Village of Dexter - Mill Creek Park - Phase 1	May 9, 2011	1
PROJECT	ISSUE DATE	ADDENDUM NO.
50094.004	P. Evanoff \ R. Abraham	
PROJECT NUMBER	PREPARED BY

THIS ADDENDUM IS ISSUED BEFORE OPENING OF BIDS TO INFORM THE BIDDERS OF REVISIONS TO THE BIDDING DOCUMENTS AND IS HEREBY MADE A PART OF THE BIDDING DOCUMENTS.

PROJECT: Mill Creek Park – Phase 1 Improvements

1 BOARDWALK PILE LAYOUT PLAN
 C-11 SCALE: 1"=30'

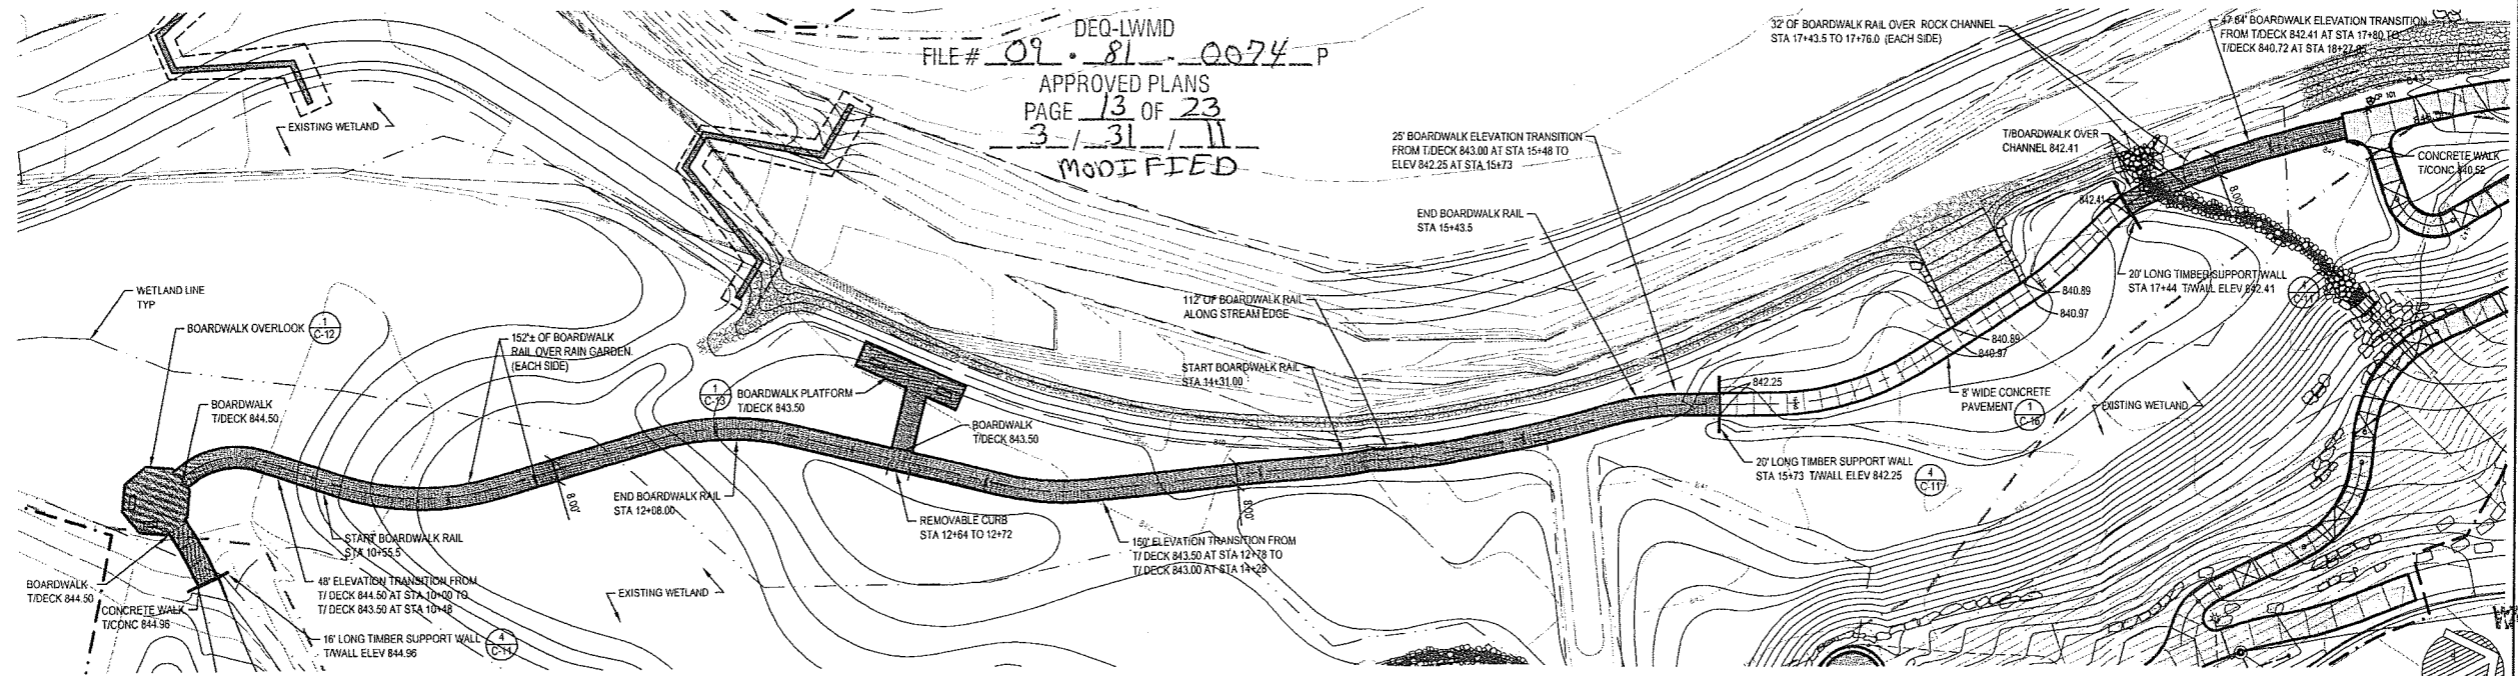
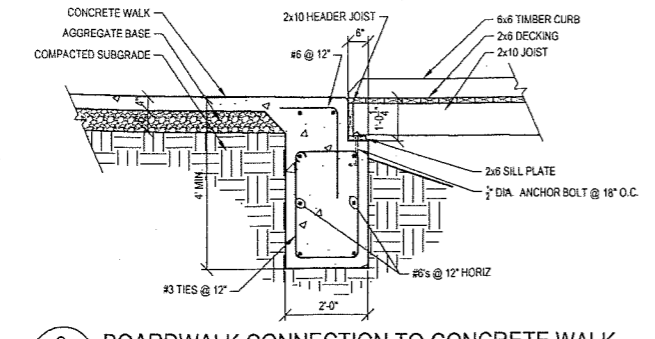
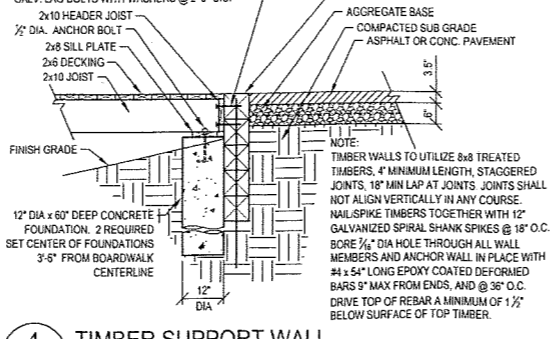
Item # 6: Refer to Sheet C-11 – Revised boardwalk note 5, Revised detail call-out for concrete walk at boardwalk.

5 WARRIOR CREEK PARK MODIFIED BOARDWALK RAILING
C-15 SCALE: 1"=1'-0"

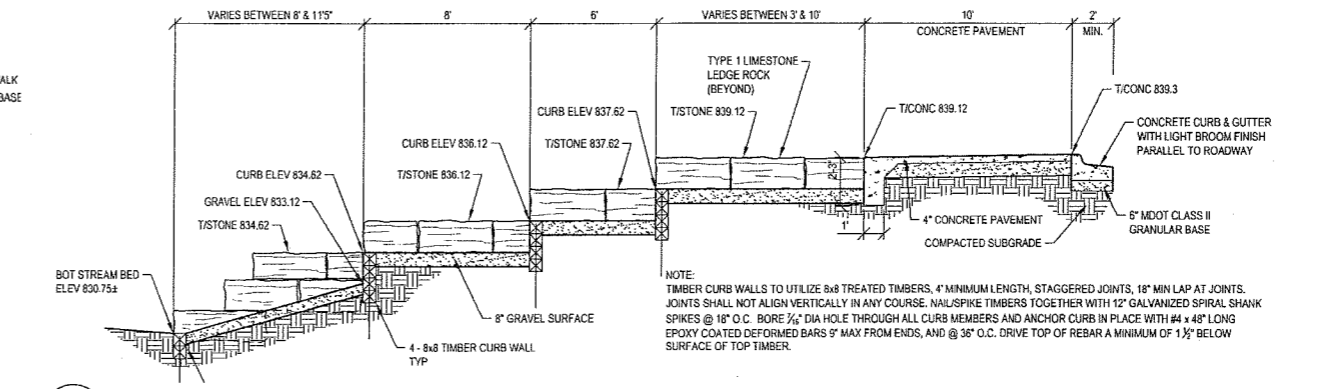
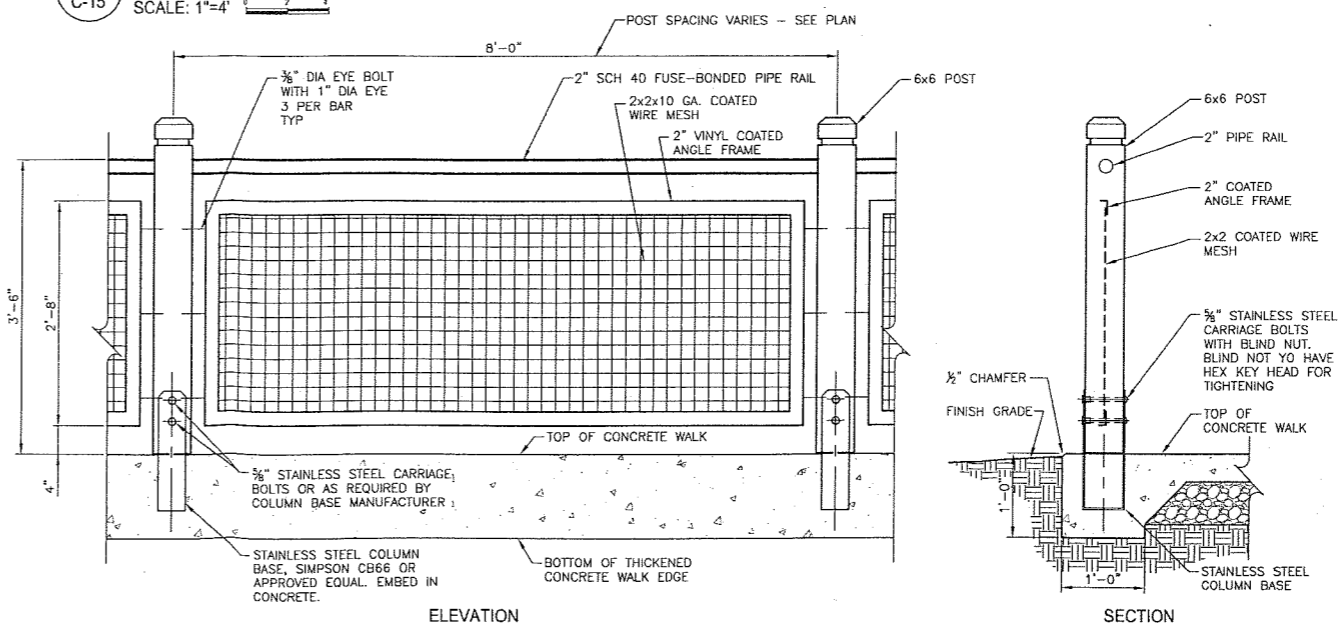
Item #7: Refer to Sheet C-15 – Added railing material specifications, Revised details 4 and 5.
